Joseph M. Farley Nuclear Plant - Units 1 and 2
10CFR50, Appendix R Exemption Request Revisions

EXEMPTION REQUEST: 2-8 Rev. 2

FIRE AREA: 2-005

GENERIC EXEMPTION REQUEST: 1-41 Rev. 1

FIRE AREA 2-005

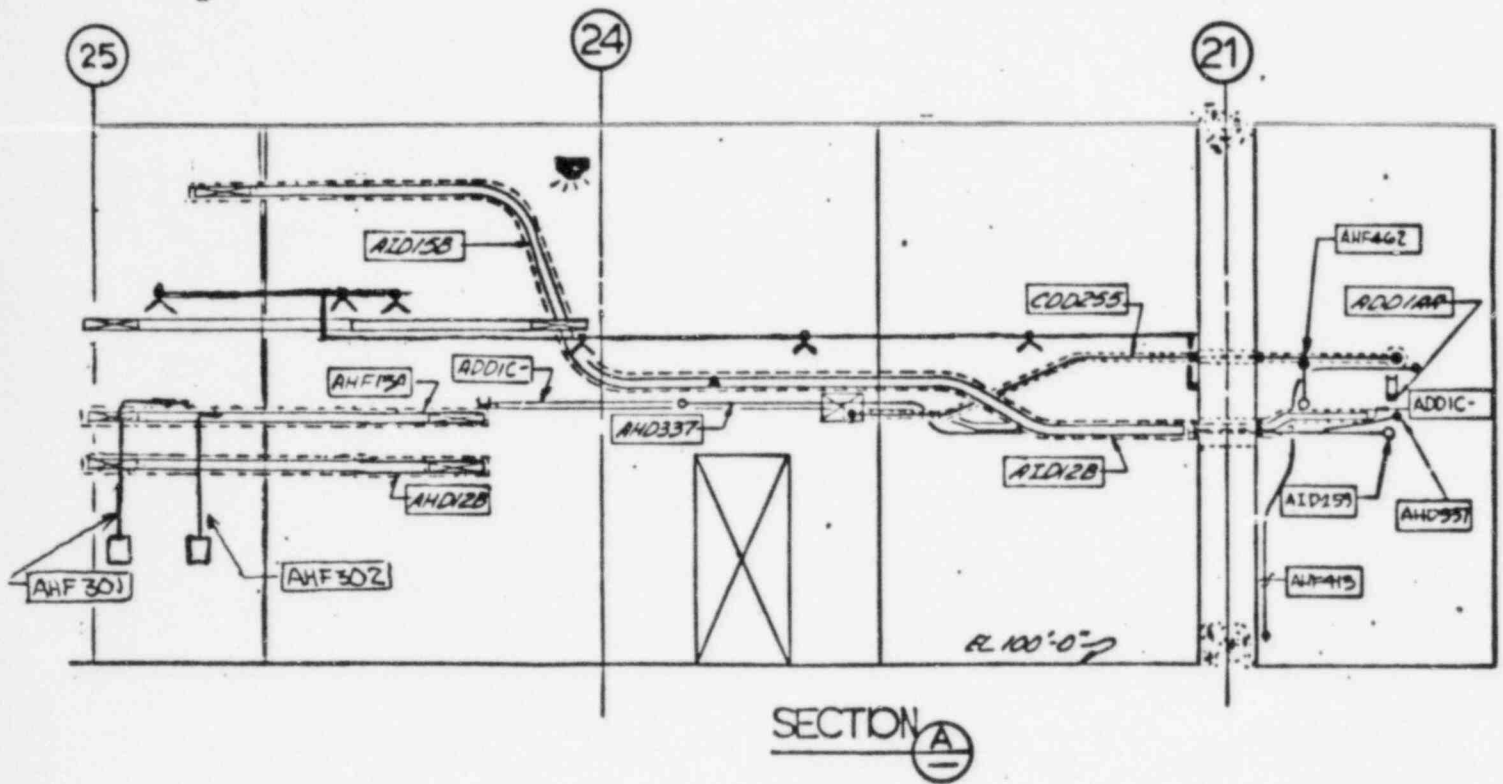
Room 2172 in fire area 2-005 contains the control cables and valves for the RWST charging pump suction (LCV115B and LCV115D), the control cables and valves for the RWMT charging pump suction and boric acid dilution injection to the VCT (FCV0113B-A and FCV0114A-A). In addition control cables for the RWM to the boric acid blender and boric acid flow control valves (FCV0114B-A and FCV0113A-A) transit this room. These components provide redundant suction of makeup water from the RWMT or the RWST. Complete fire barriers and full suppression coverage is not provided for the valves or cables. The analysis of the effects of a fire upon the subject cables in the area shows that the RWST isolation valves could become electrically inoperative in the closed position or makeup to either the VCT or charging pump suction header could be isolated.

A fire barrier has been provided for raceway sections AHF15A, AHD12B, AID258, AID12B and AID15B in rooms 2182 and 2172 of fire area 2-005. These barriers protect cables for the boric acid flow control and the RWM to the boric acid blender valves (FCV0113A-A and FCV0114B-A) as they transit rooms 2182 and 2172 of fire area 2-005. These subject barriers also provide protection for the RWMT charging pump suction, boric acid dilution injection to the VCT cables (FCV0113B-A and FCV0114A-A) and the redundant RWST charging pump suction train A cables (LCV0115B-A), with separation of approximately 19 feet. Partial suppression coverage is provided for the subject cables and valves in this area of FCV0113B-A and FCV0114A-A. There is approximately 15 feet of separation between the RWMT charging pump suction valve and cables (FCV0113B-A) and the redundant train B RWST suction valve and cables (FCV0113B-A) and the redundant train B RWST suction valve and cables (LCV0115D-B). Again partial suppression coverage is provided in the area of FCV0113B-A and FCV0114A-A. Detection is provided in the area of the subject components. Due to the barriers provided; the spatial separation, detection and partial suppression coverage and the low insitu combustible loading (much of which has now been covered in a fire barrier) a credible exposure fire would not affect both redundant sources of borated makeup water. In the event of a fire in Room 2181, the Train B RWST isolation valve, LCV115D-B will be operable. An automatic suppression system covers the raceway to be protected with the exception of 18 feet of raceway sections AHF15A, AHD12B and AID15B in Room 2172 and 10 feet of AHF15A and AHD12B in Room 2182.

In the unlikely event that a fire in this area caused a loss of these three independent sources of reactor makeup water, the additional fire barriers that have been installed in Rooms 2182 and 2172 will ensure that a fire induced RCS letdown will not exist thus increasing the time margin available to establish makeup. Reactor decay heat will be sufficient to maintain RCS temperature and thereby prevent shrinkage of the RCS until manual action can be taken to restore makeup water. In addition, the Reactor Coolant Pump seal integrity can be maintained by the normal seal injection flow path from the VCT or by using Component Cooling Water. These flow paths will not be affected by a fire in this area; therefore, the integrity of the pump seals will not be jeopardized while makeup is being established.
